ADDENDUM NO. 2

Life Sciences Collaboration
 1910 N. Antelope Valley
 Parkway
 Lincoln, Nebraska
 TCEP No.: 716-002-12
 Davis Design.: 12-0077
 BVH No.: L12018.unl
 November 27, 2013

Electrical Site Utilities
Plan

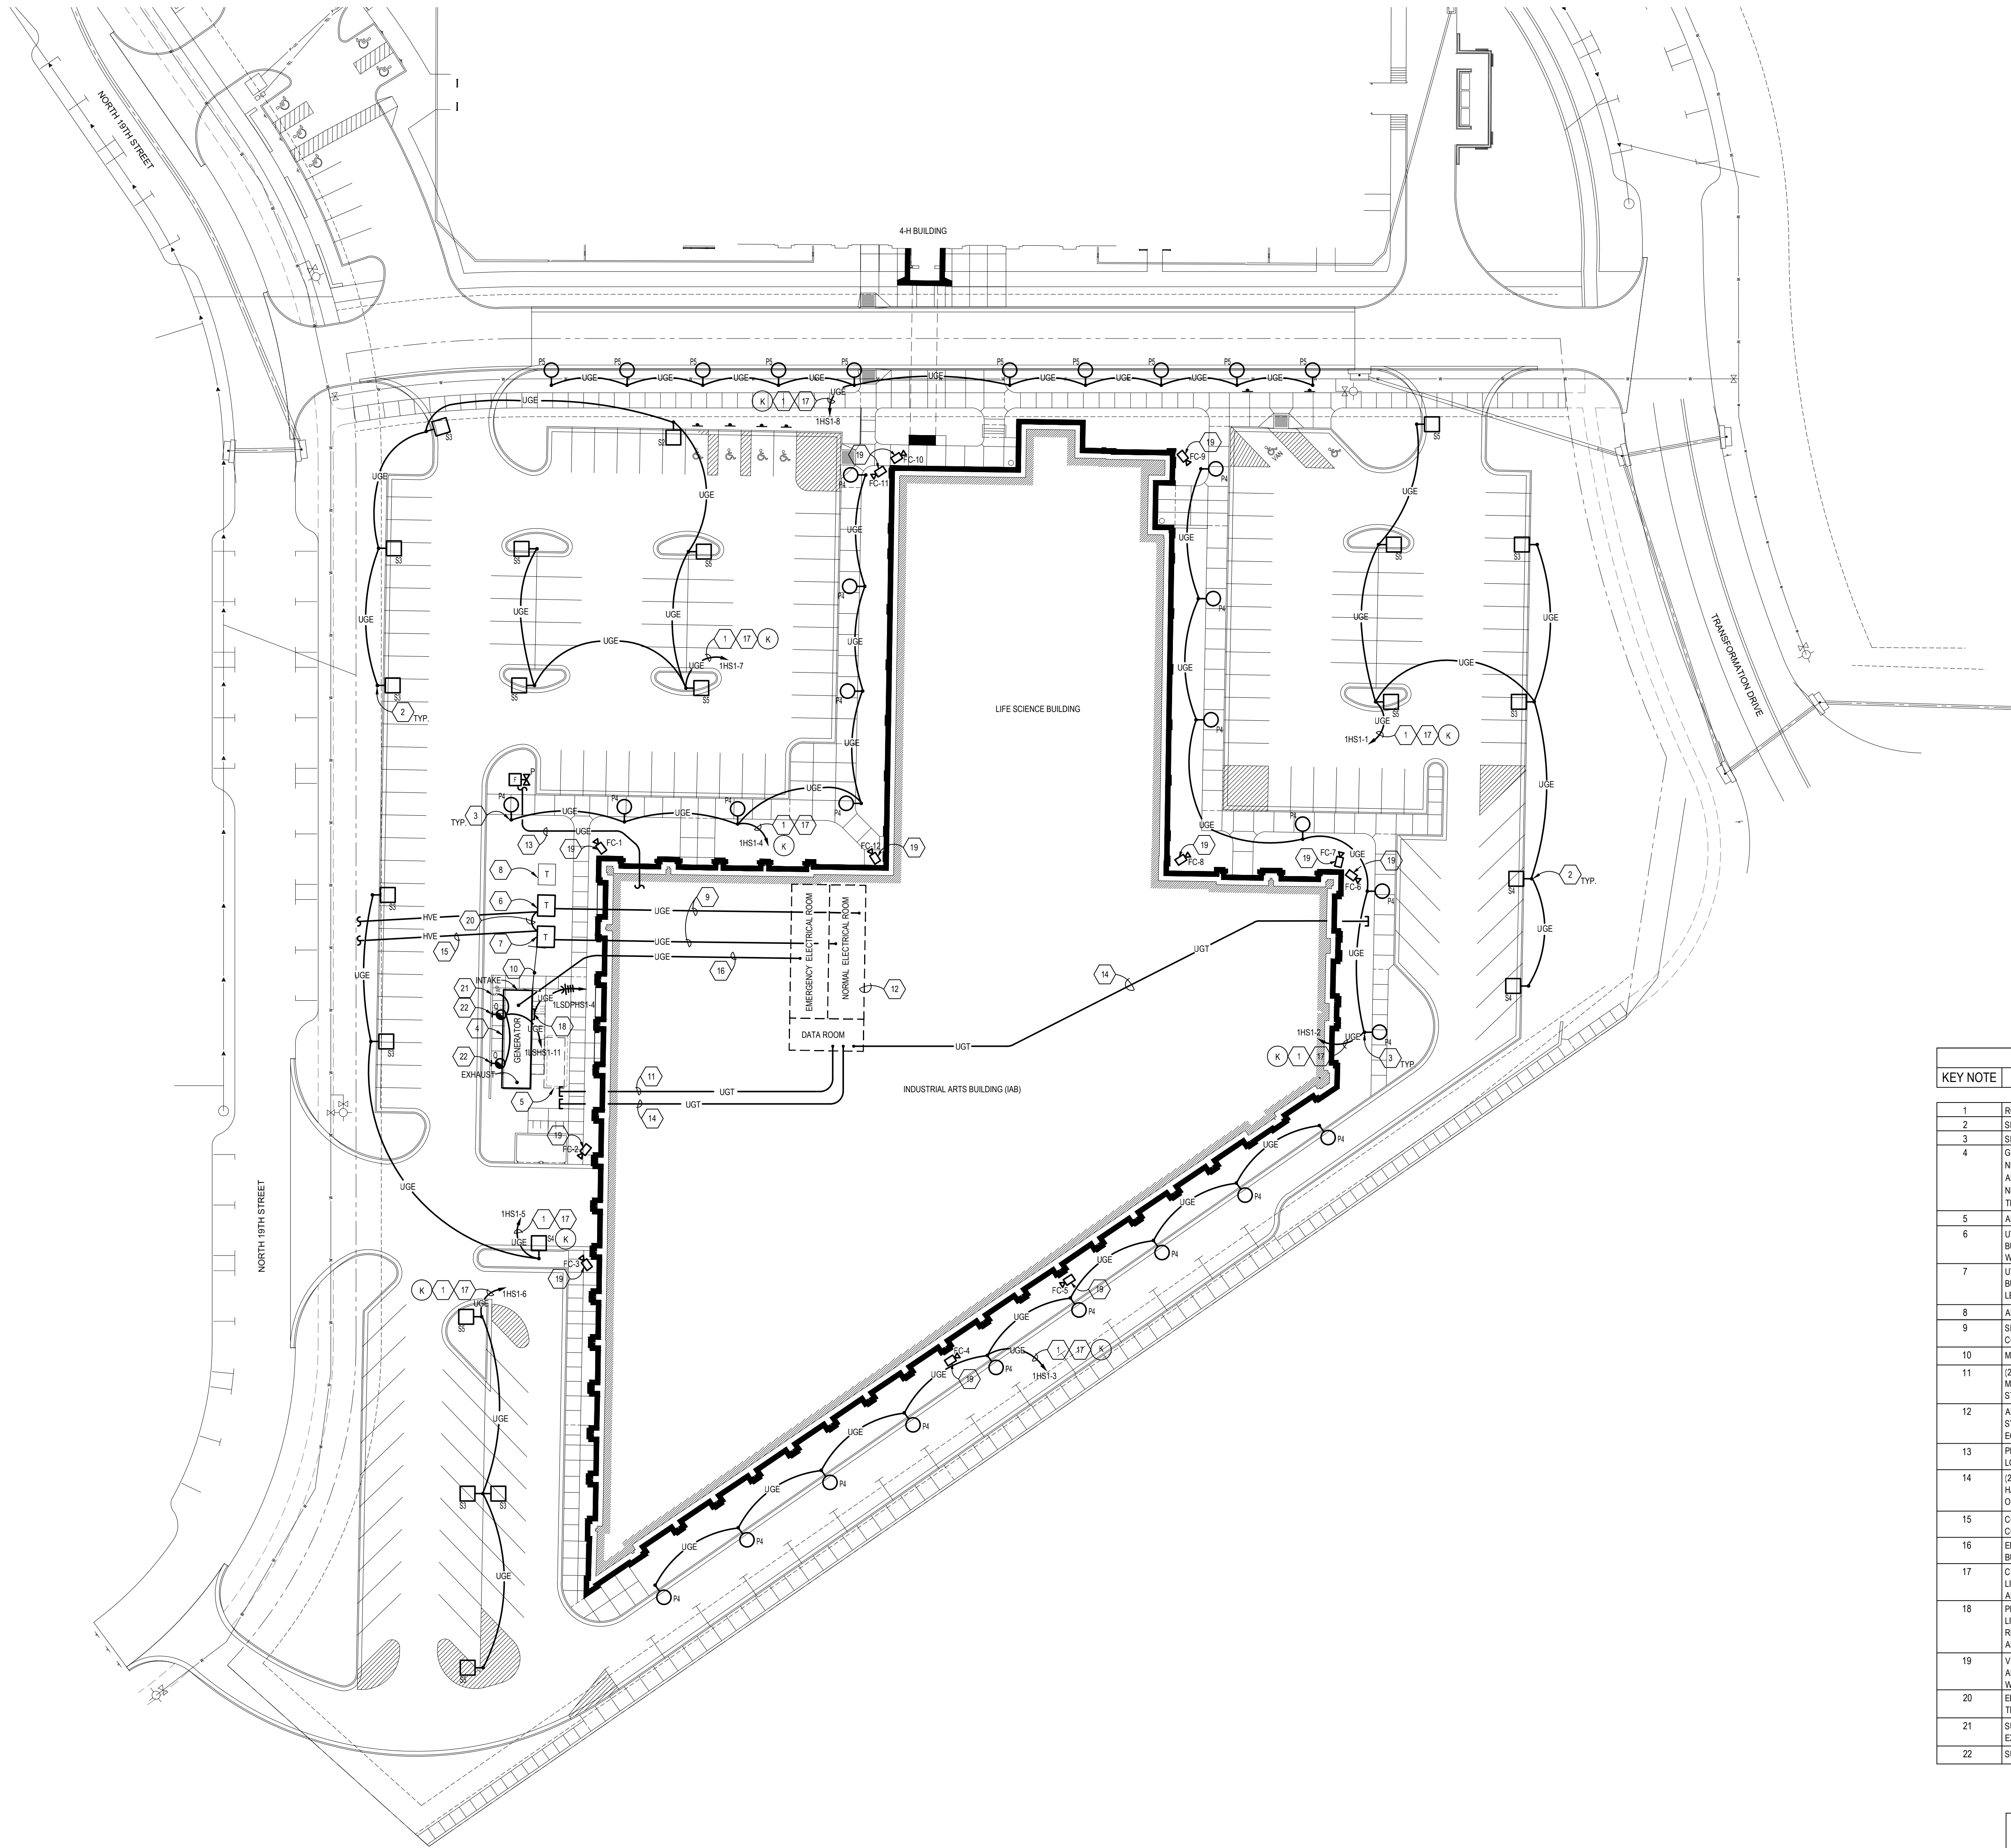
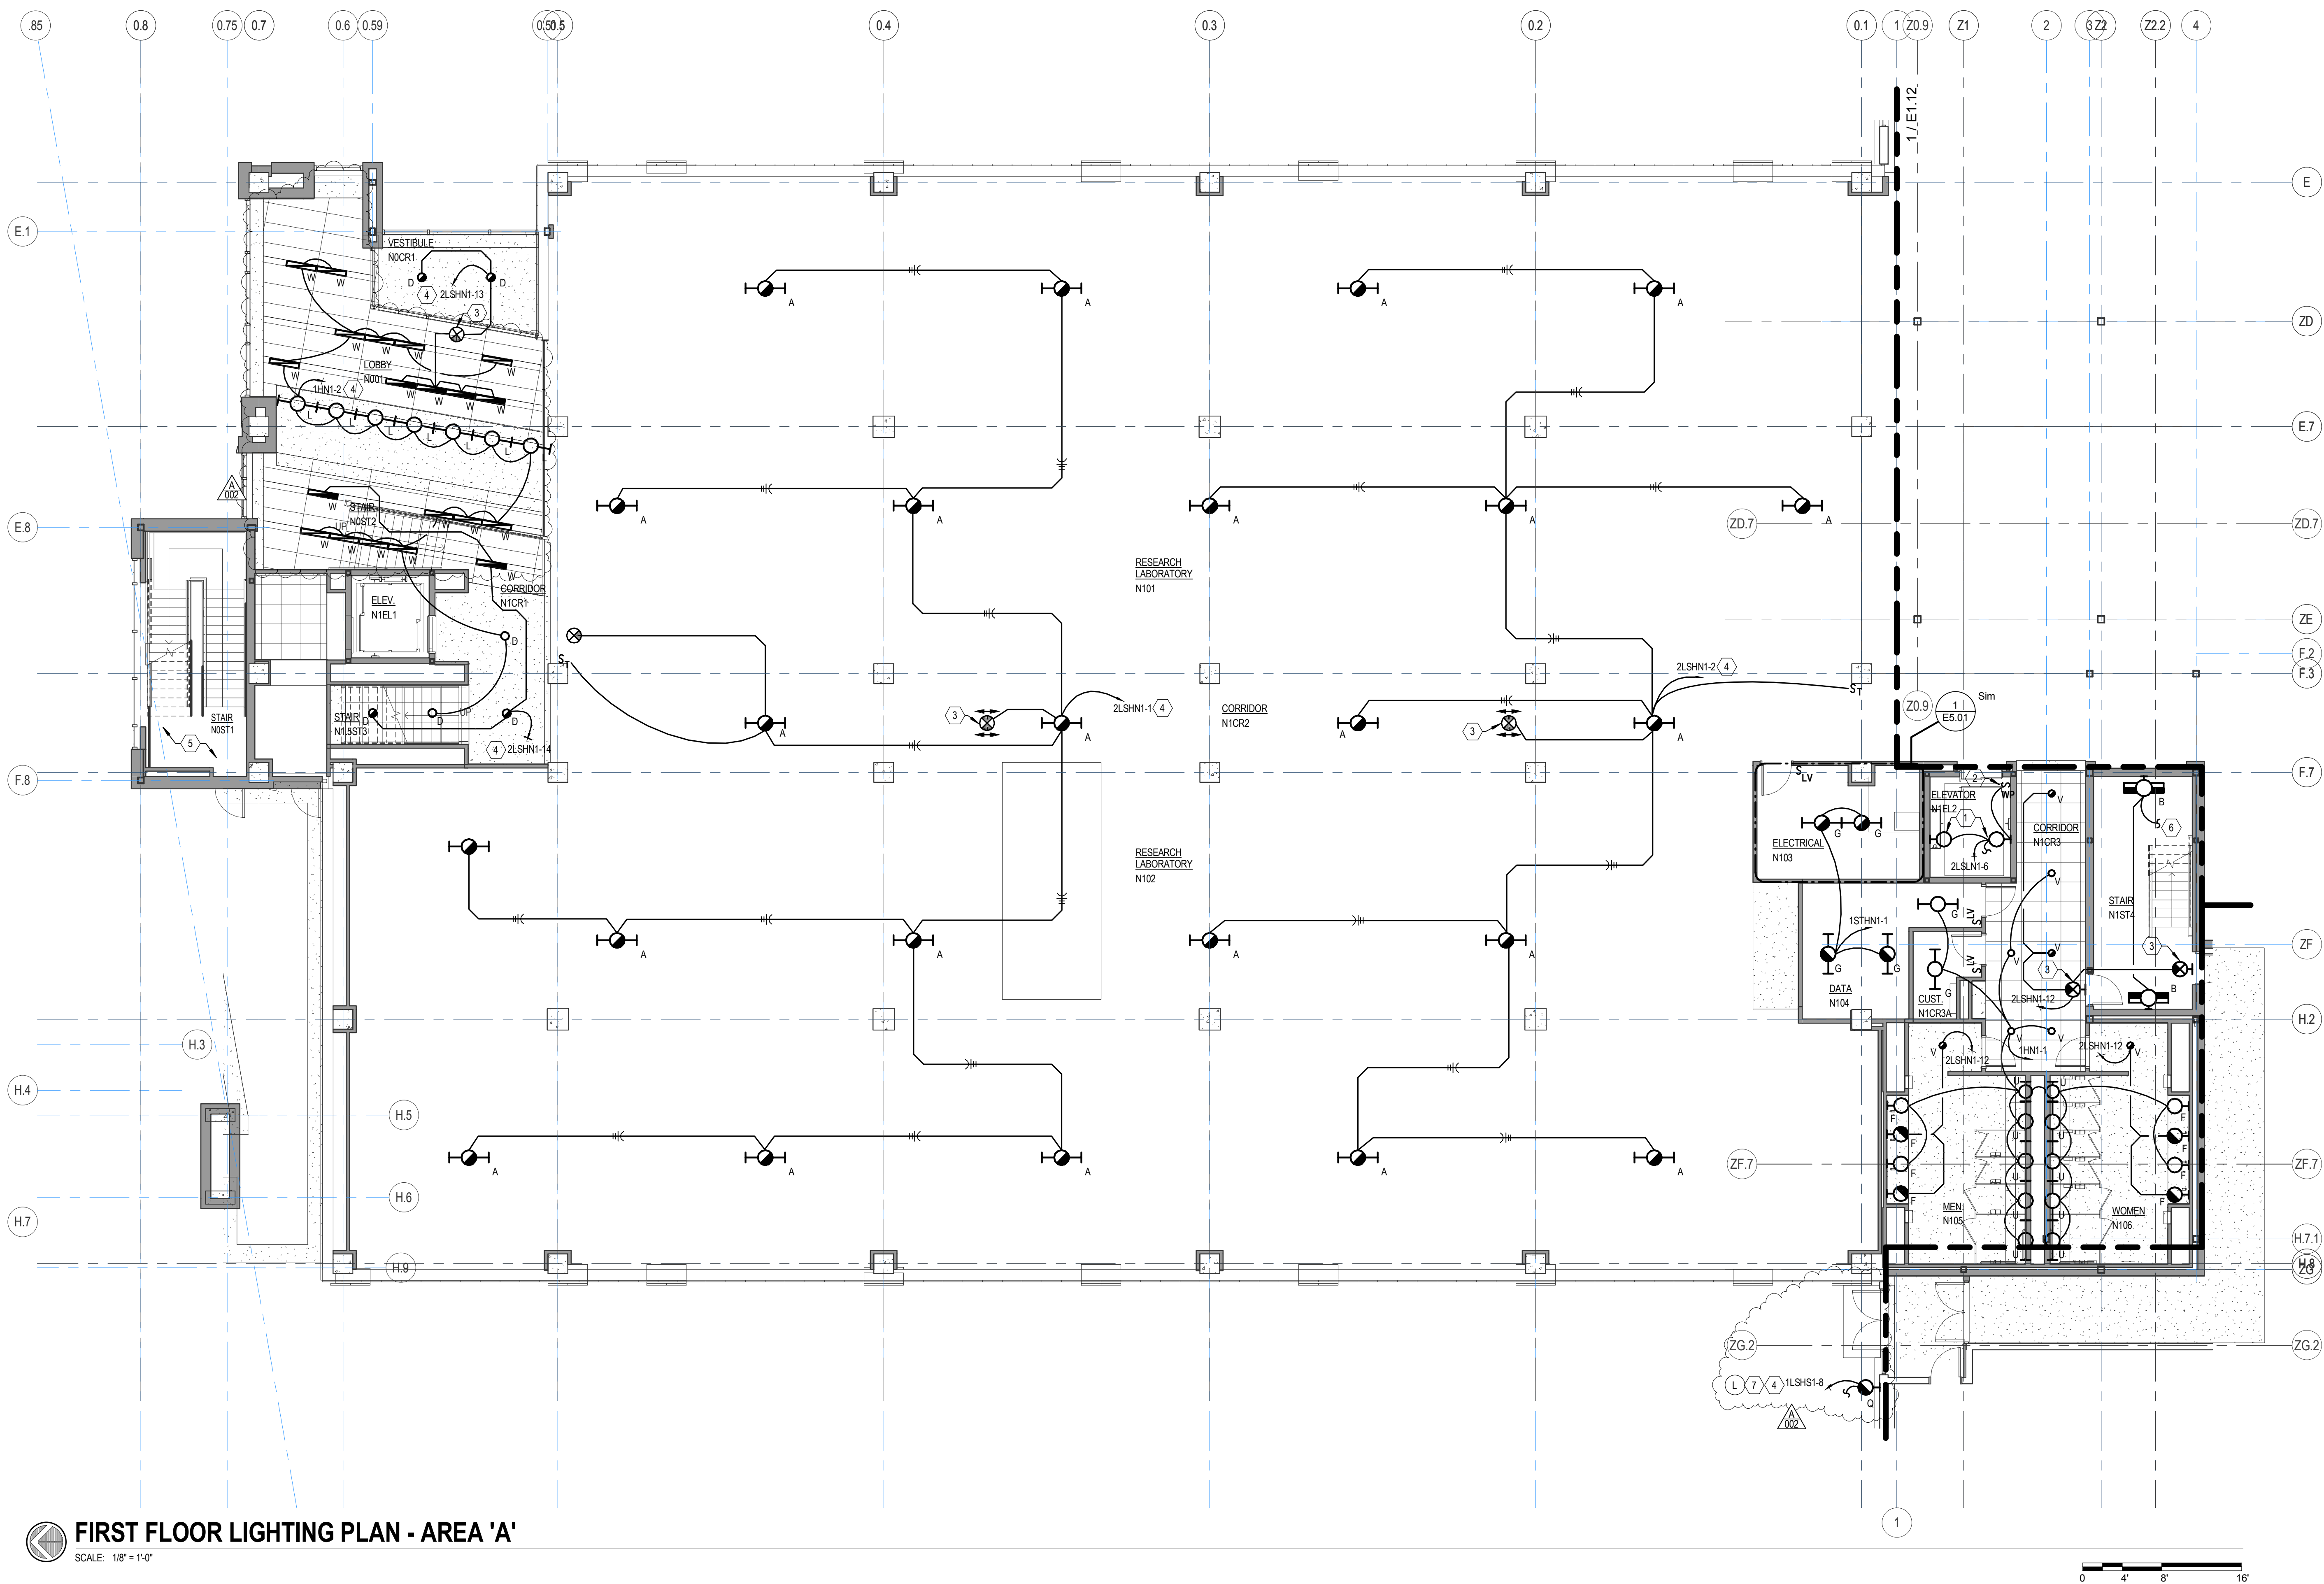
Item 2-69: Sheet E0.01 – Electrical Site Utilities Plan

Site lighting and additional details have been modified. This sheet is being re-issued in its entirety as a part of this addendum. See re-issued sheet E0.01 for changes.

First Floor Lighting Plan -
Area 'C'

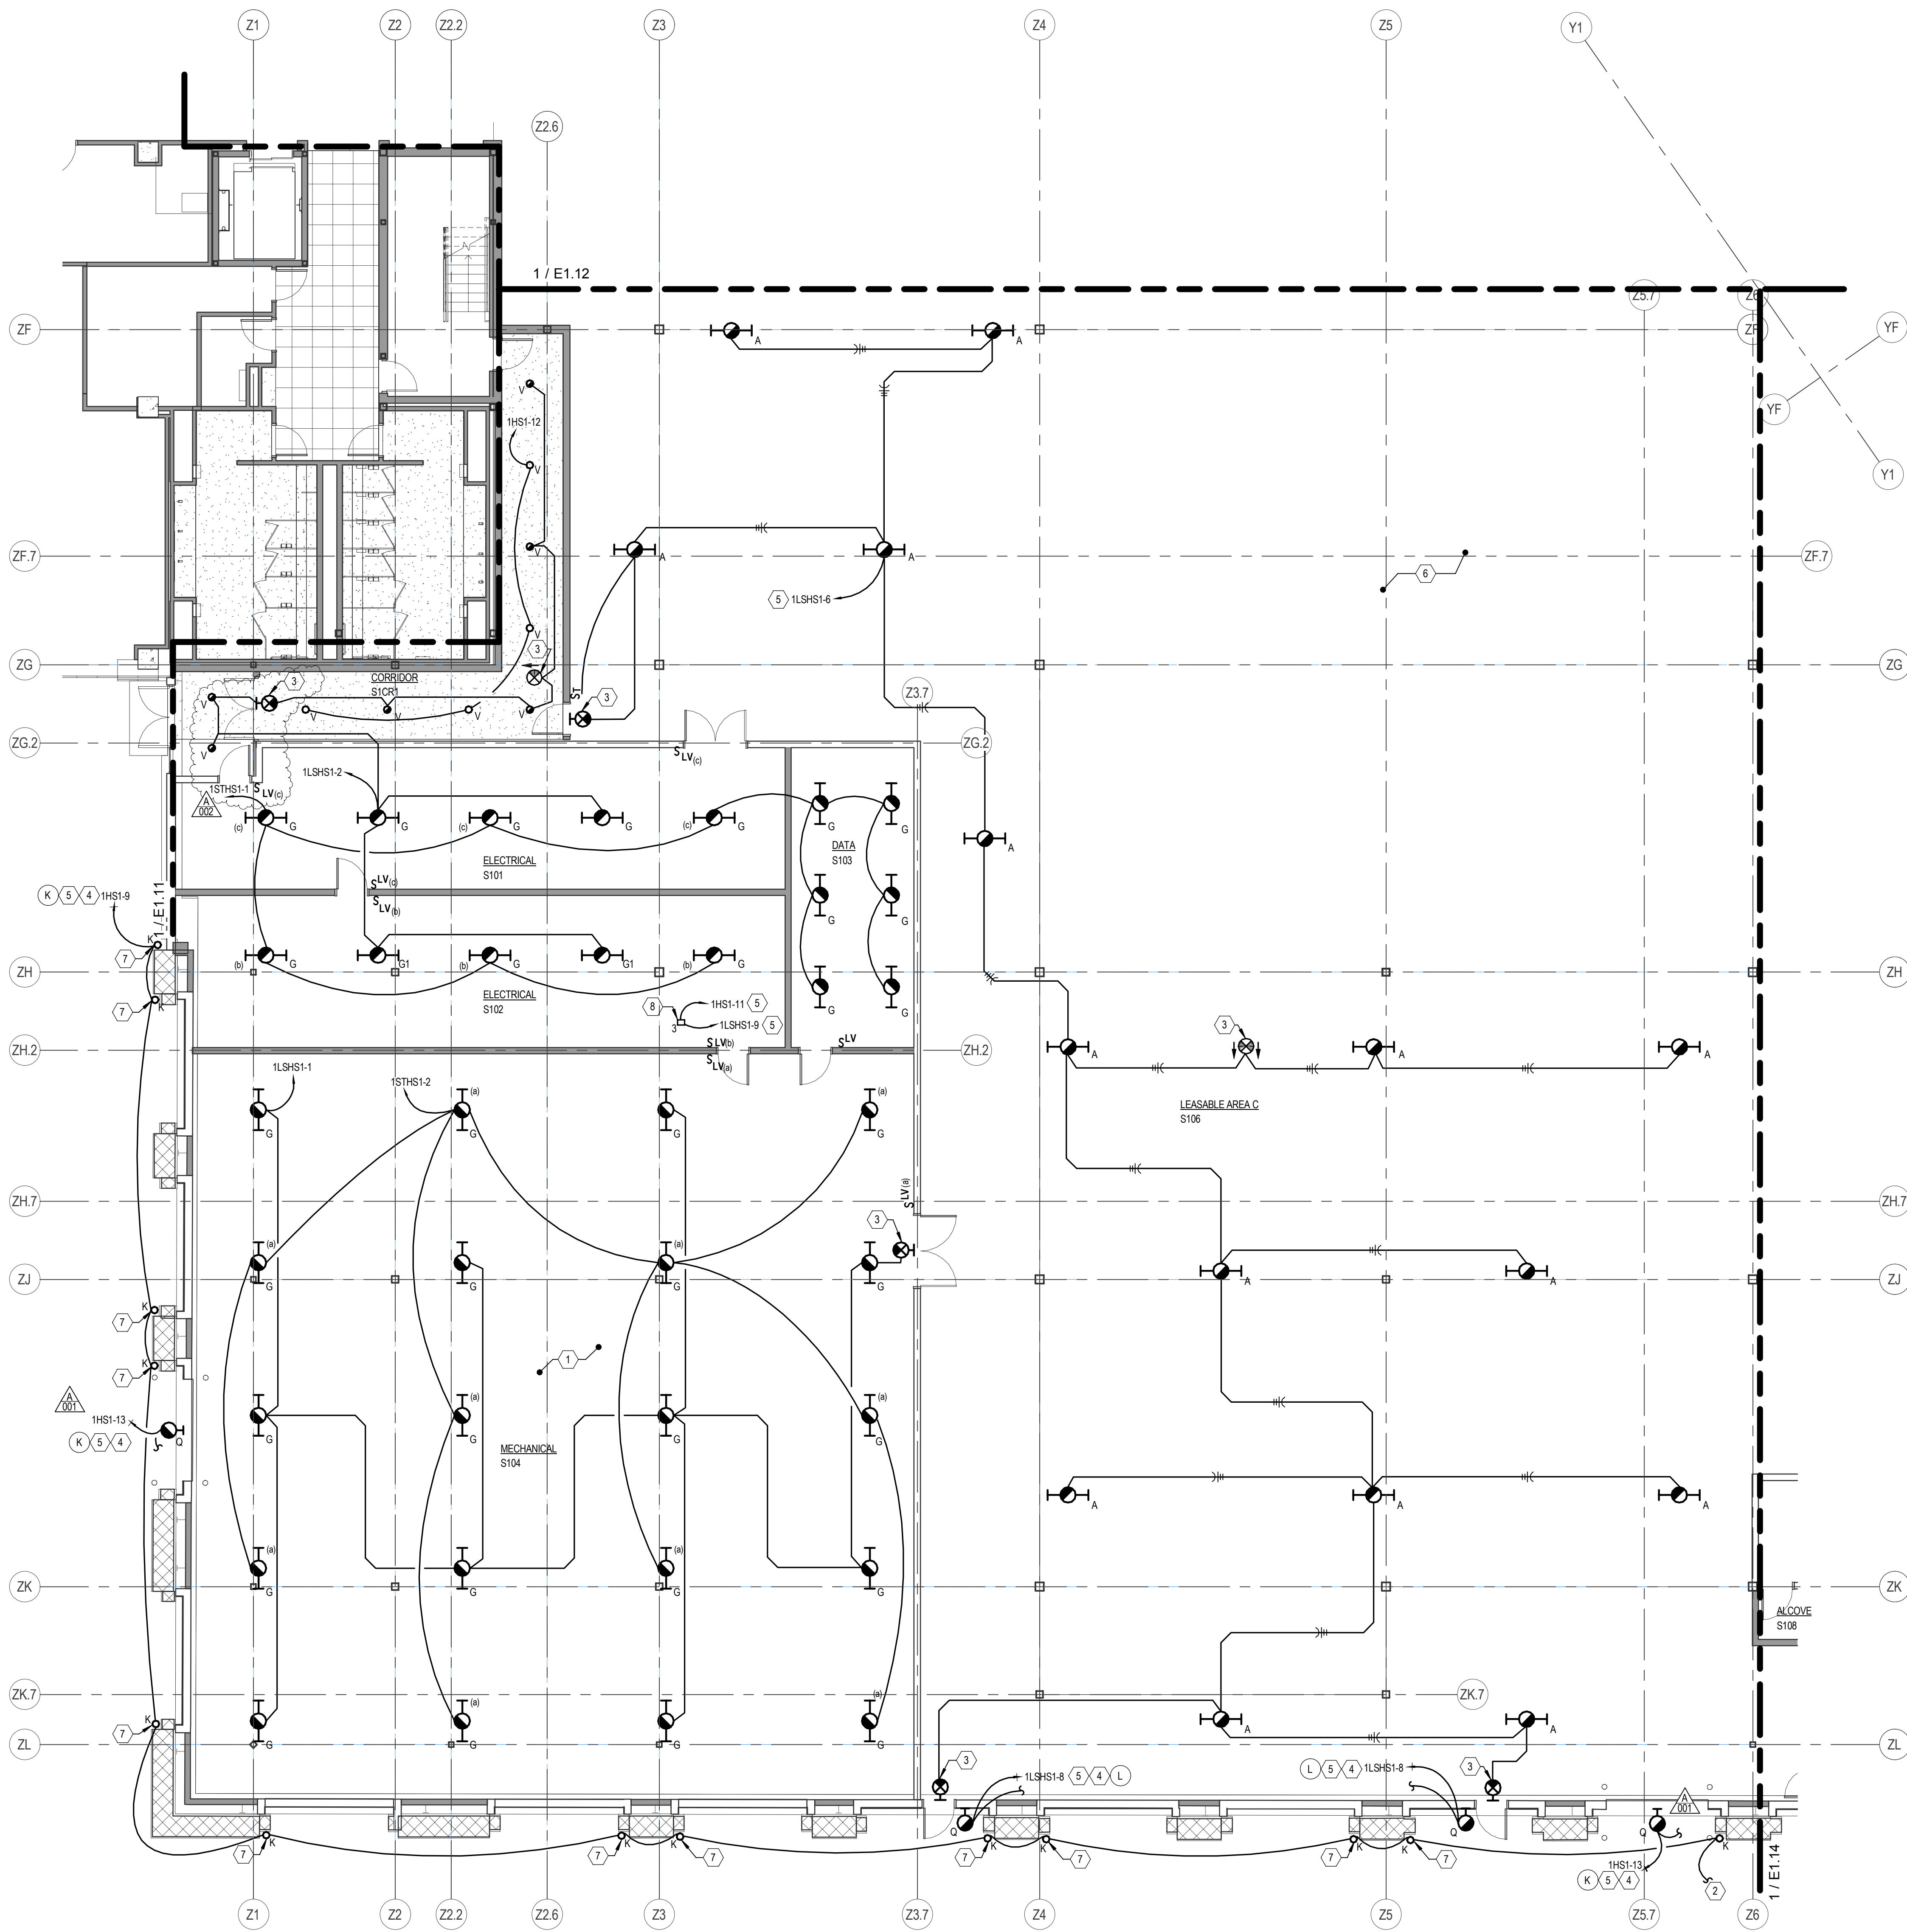
Item 2-71: Sheet E1.13 – First Floor Lighting Plan – Area ‘C’

Changes in lighting fixtures to coordinate with Vestibule addition. See re-issued sheet E1.13 for changes.
